# **BUTTE REGIONAL TRANSIT OPERATIONS CENTER**

Tenant Improvement

## **ADDENDUM NO. 3**

1/18/2016

**3** PURLIN TO HSS BEAM  
1 1/2" = 1'-0"

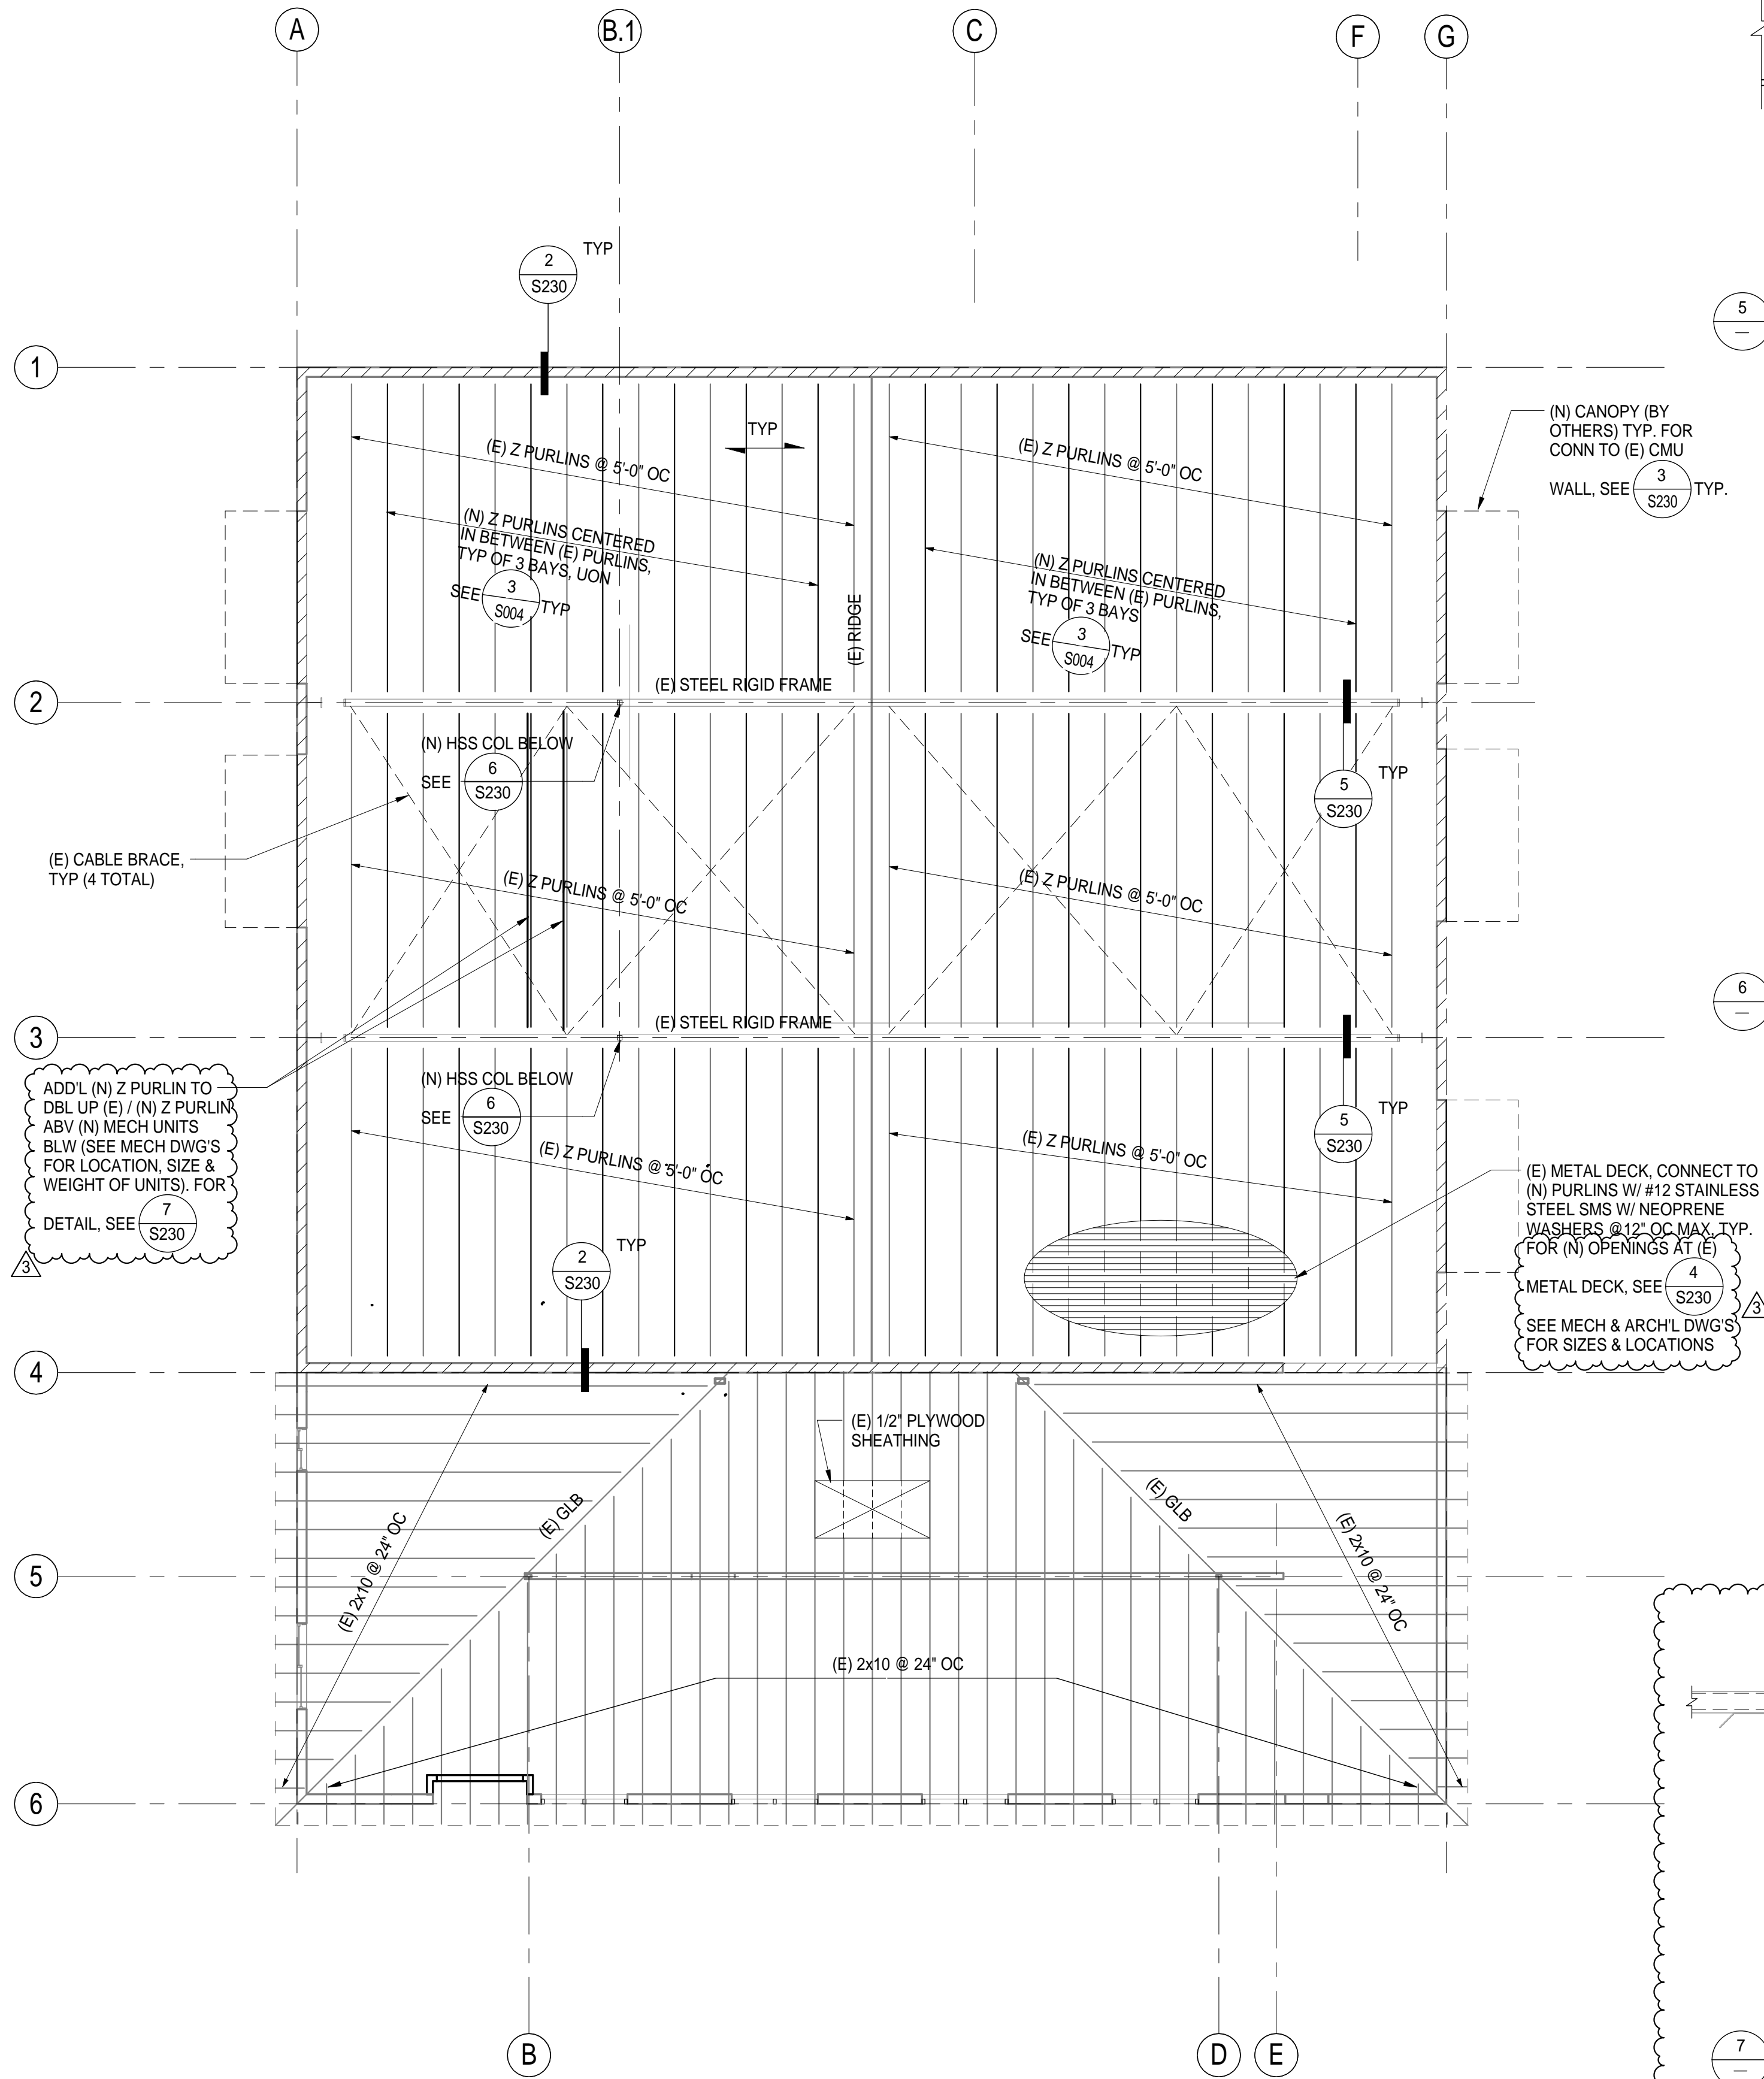
- 1.8 REVISION TO DRAWING S220 – PARTIAL CEILING FRAMING PLAN & DETAILS
  - a. Plan 1 – Add note for attachment of plywood to Z purlins. Detail 3 – Extended plywood over and attaching to HSS beam.

JOB NO. 5006A3	SHEET <b>E201</b>
DATE 12/3/15

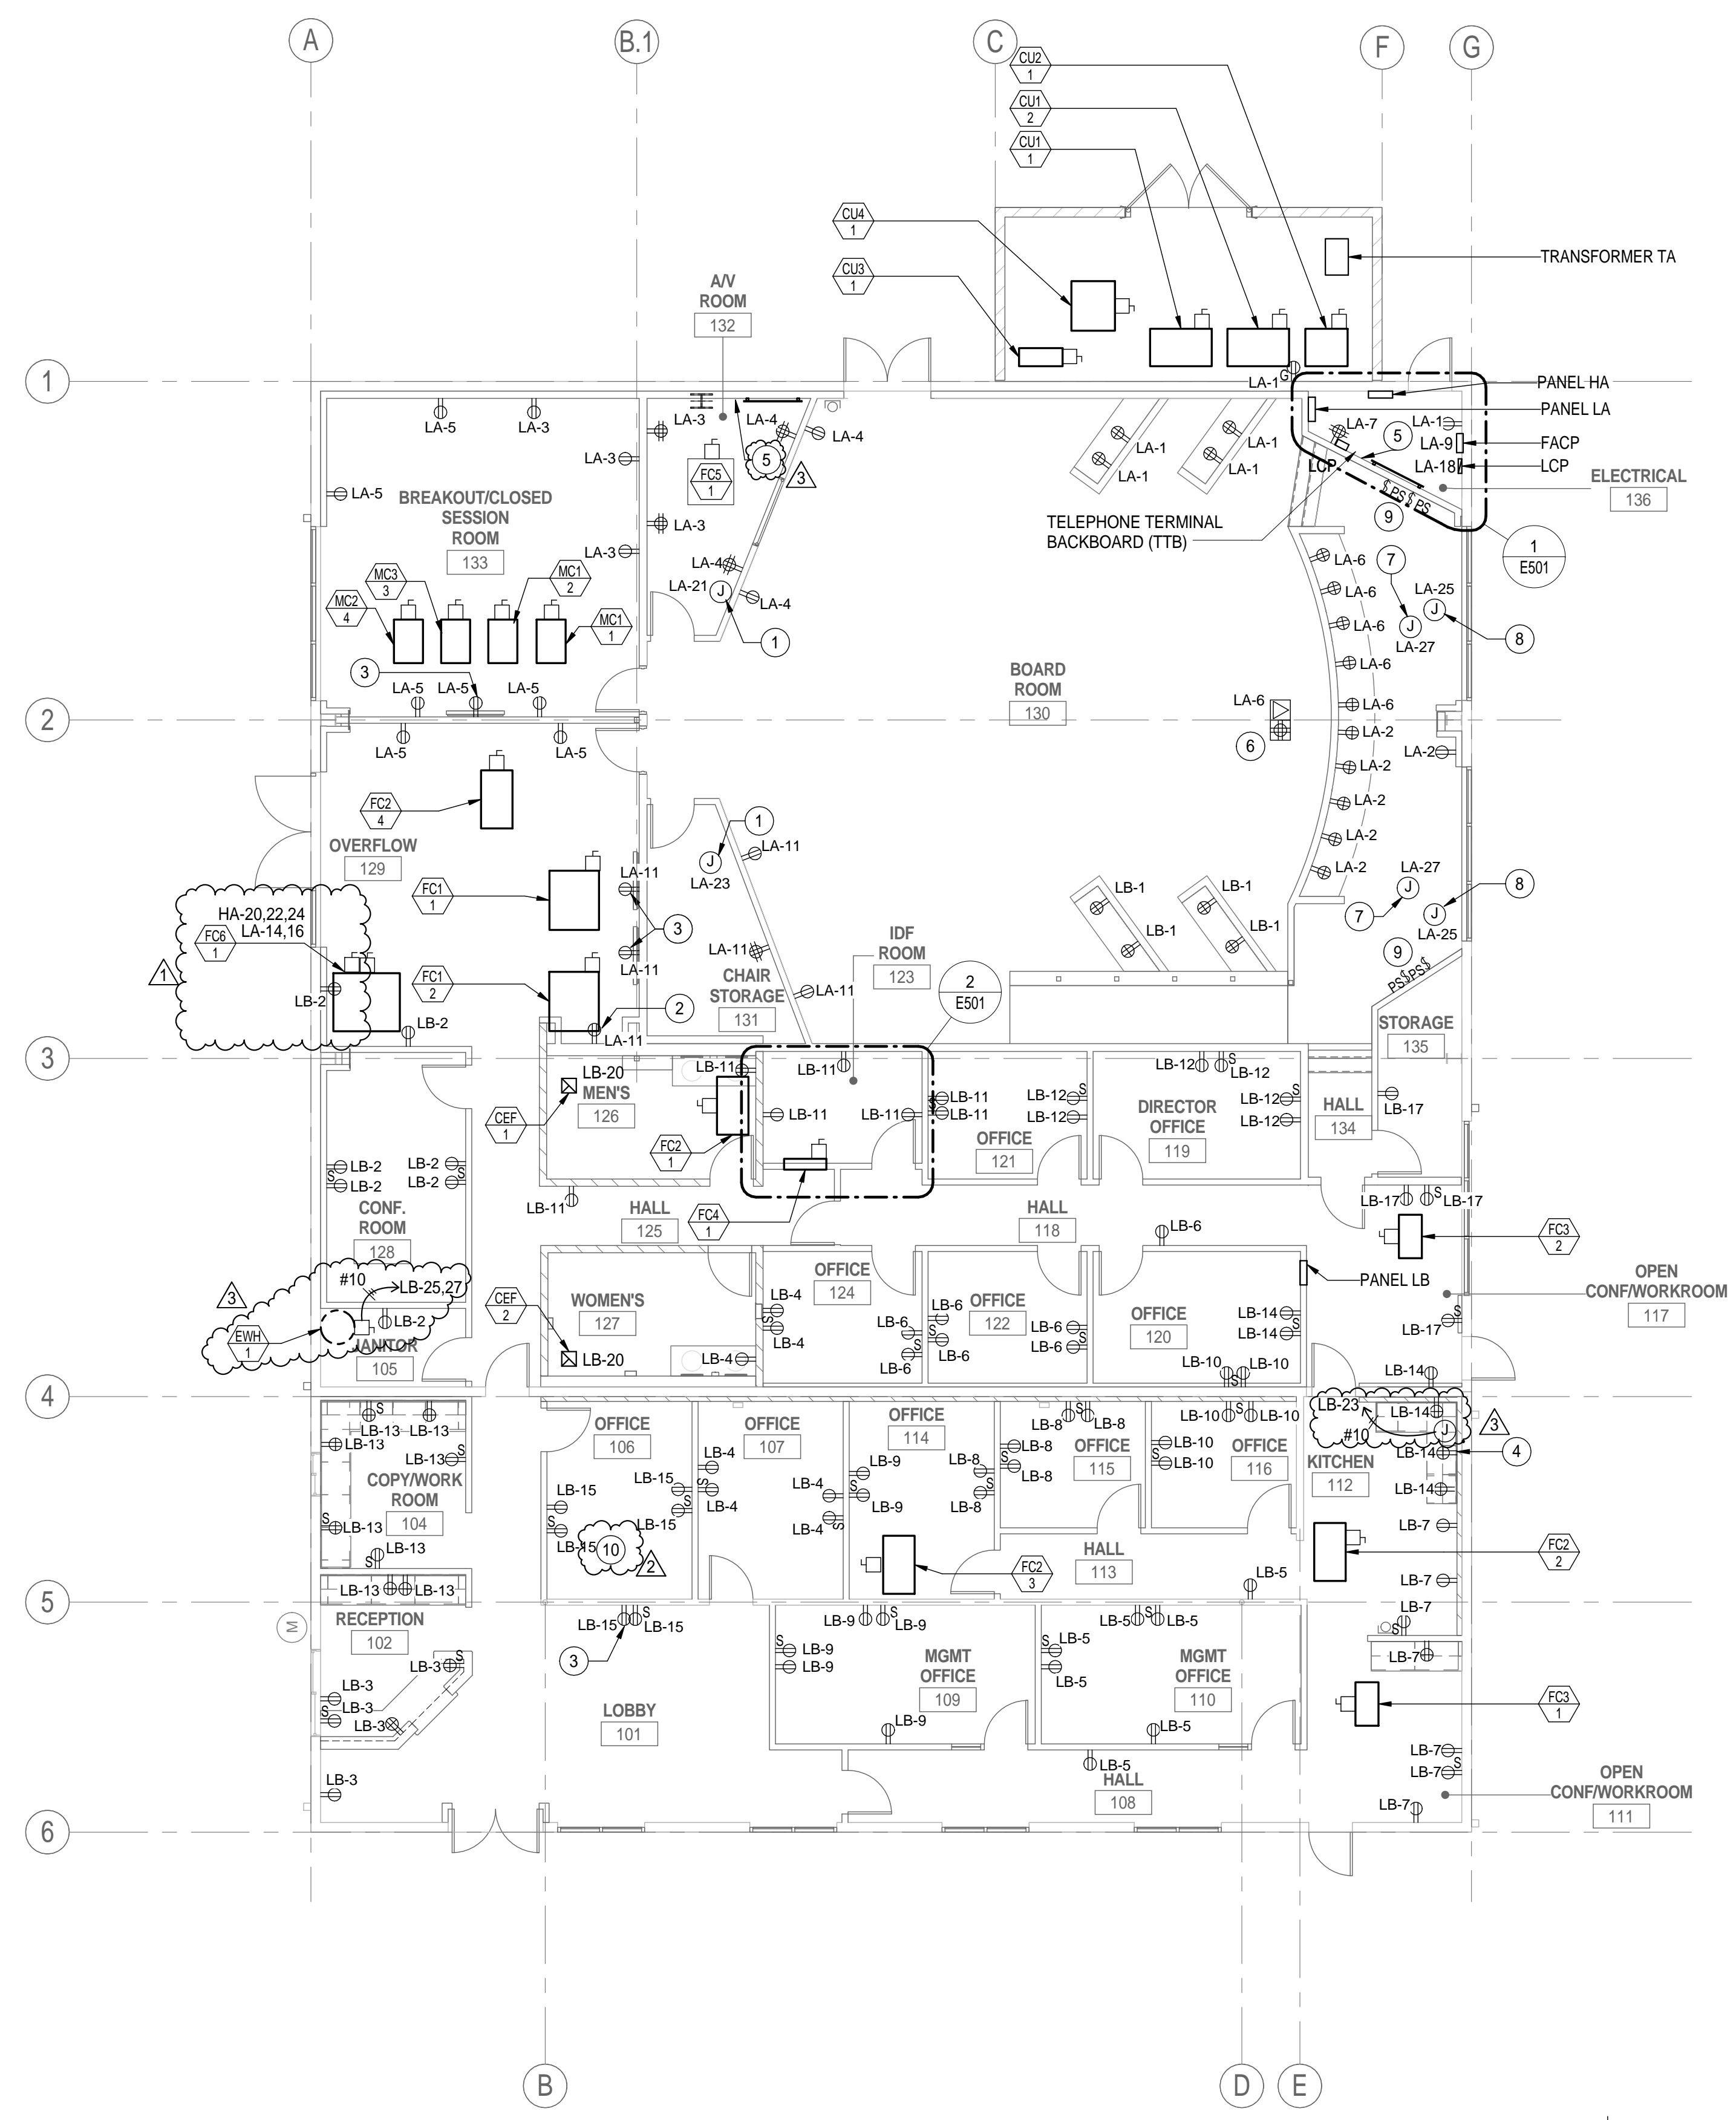
- 1.16 REVISION TO DRAWING E201 – ELECTRICAL POWER PLAN
  - a. Added General Note 2 clarifying that all branch circuits are included. Added Keynote 5 to A/V room for additional conduits to IDF Room.

- b. Added disconnect for the electric water heater. See Mechanical Schedule.
  - c. Added junction box for instant water heater.
- 1.17 REVISION TO DRAWING E805 – ELECTRICAL PANEL SCHEDULES

- a. Added General Note 2 clarifying that all branch circuits are included. Added Keynote 5 to A/V room for additional conduits to IDF Room.
  - b. Added disconnect for the electric water heater. See Mechanical Schedule.

- c. Added junction box for instant water heater.

**P201**

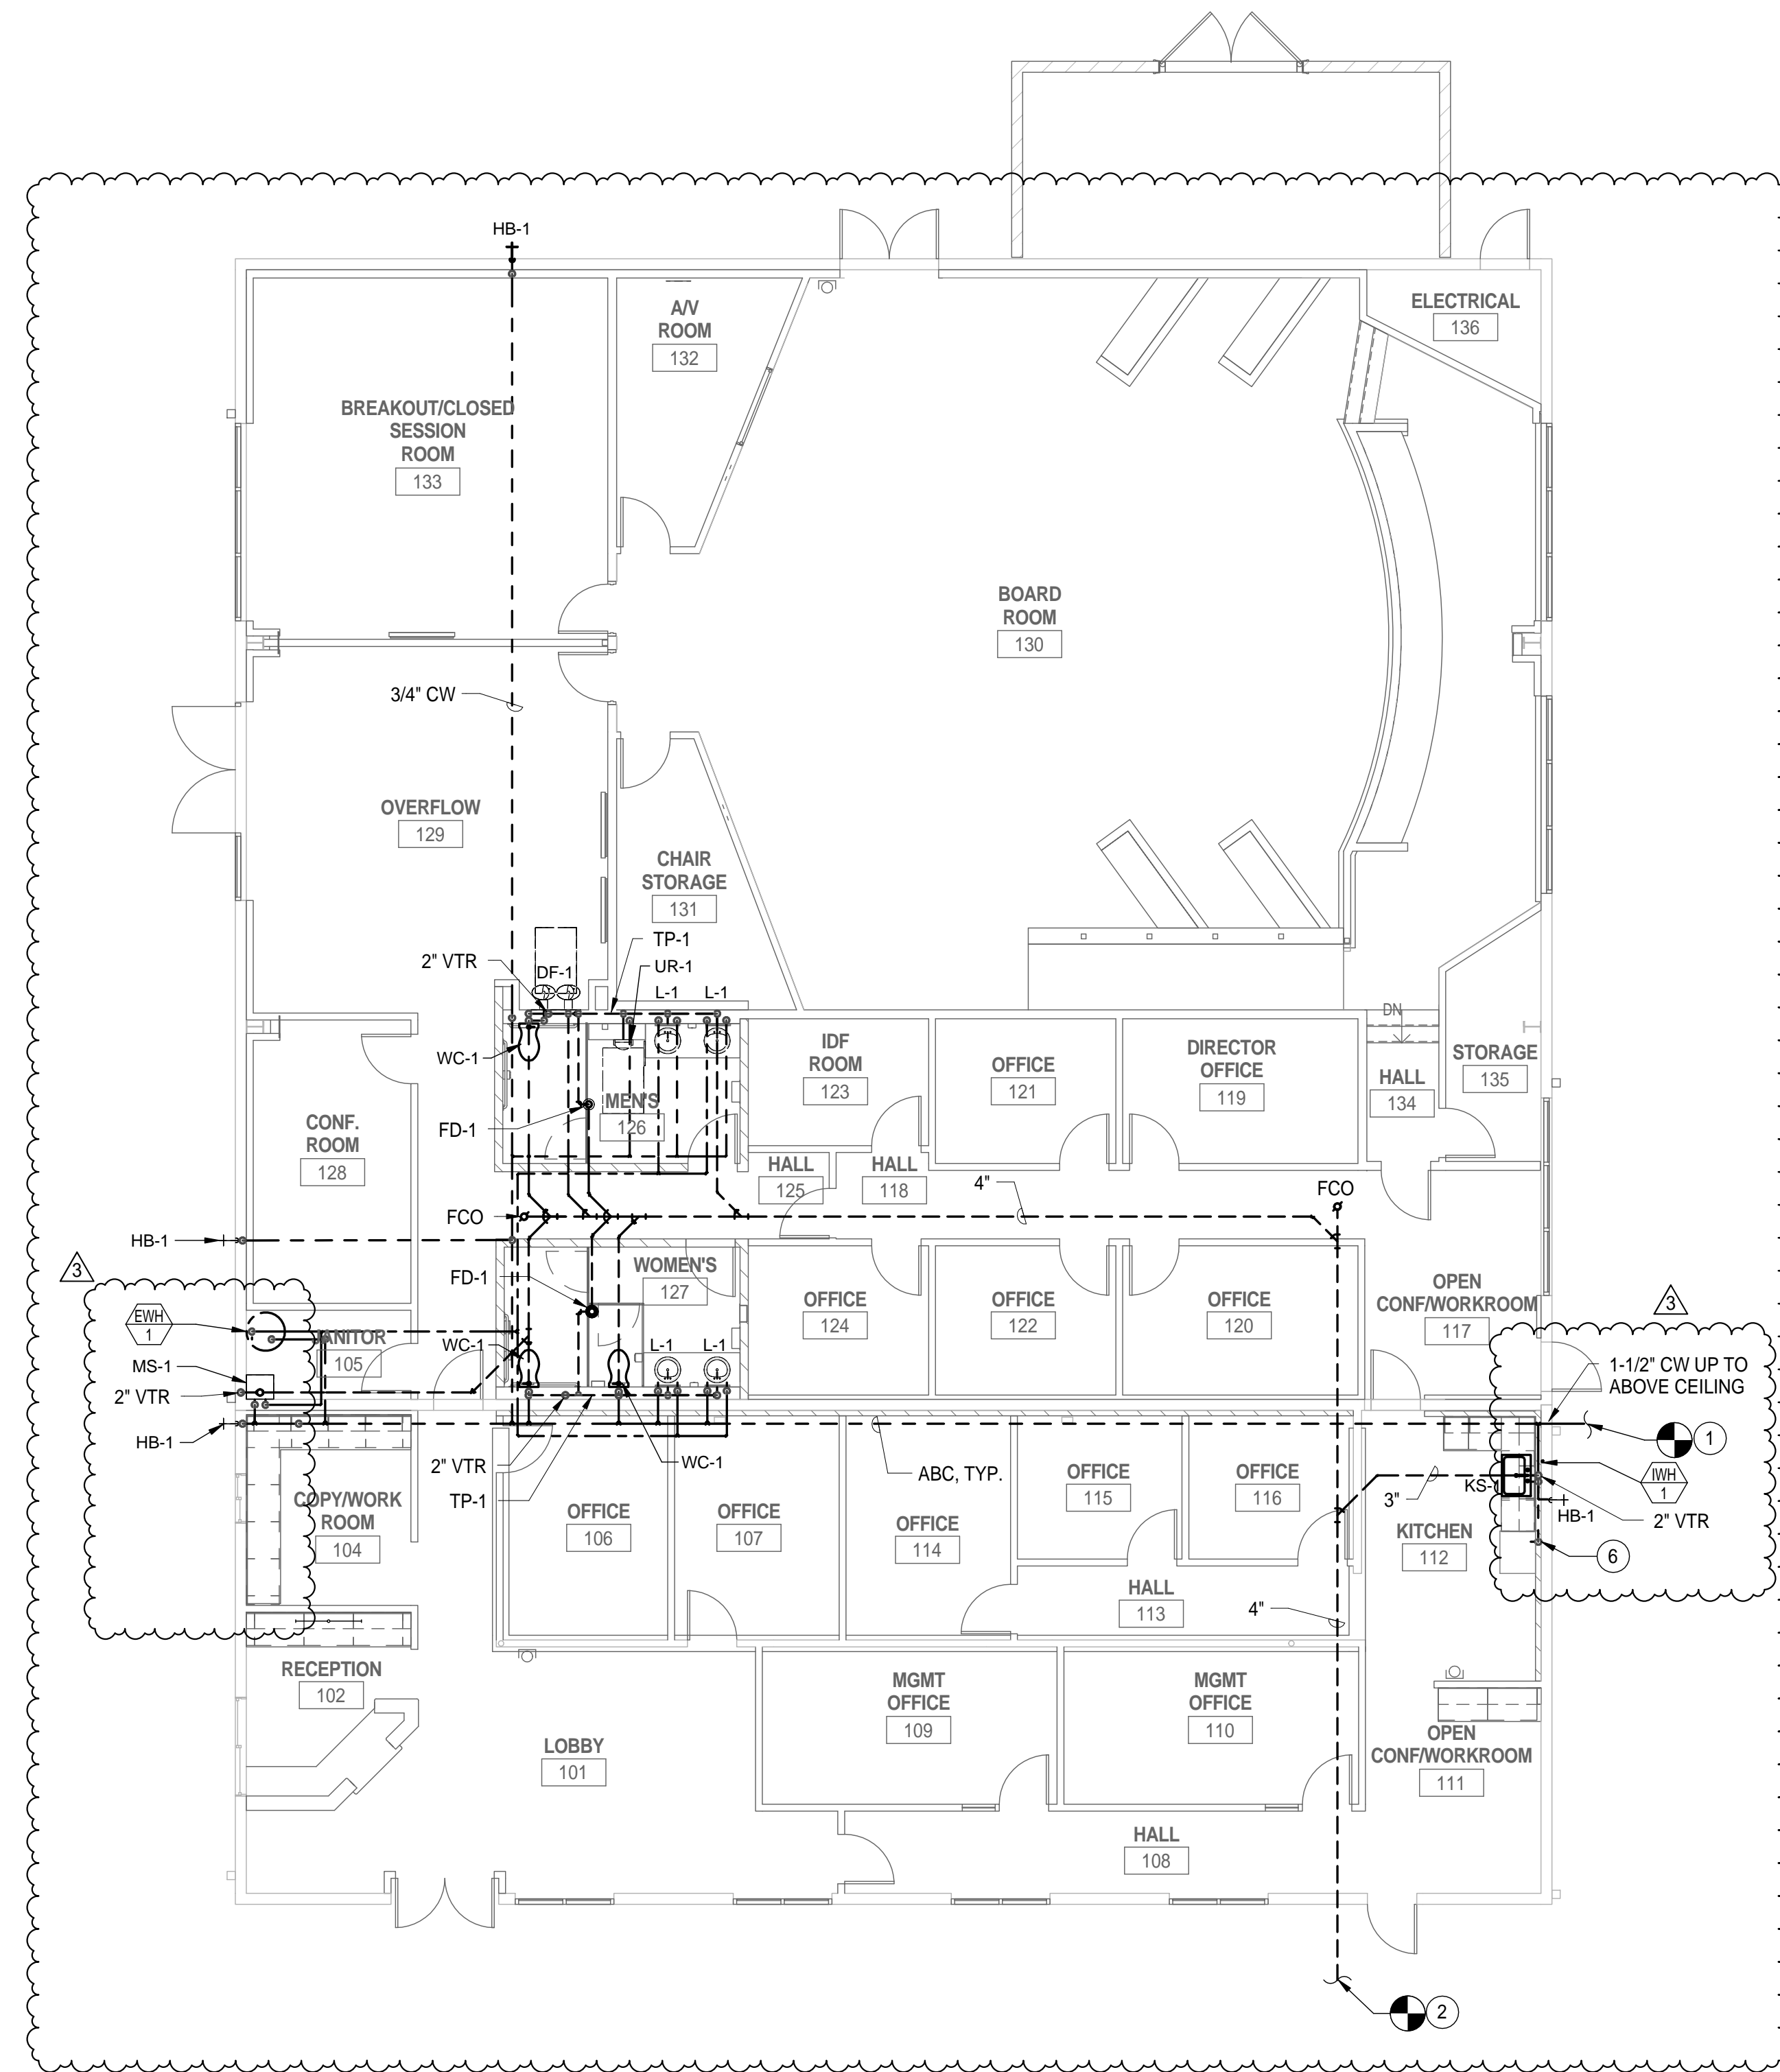
- e. Added Water Calculations.
- 1.19 REVISION TO DRAWING P201 – PLUMBING FLOOR PLAN WITH PLUMBING FIXTURES LOCATED
  - a. Deleted Gas Water Heater Detail.

- b. Added Electric Water Heater Detail.
  - c. Added Instantaneous Water Heater Detail.
  - d. Revised plan to locate electric water heater.
  - e. Revised plan to locate instantaneous water heater.
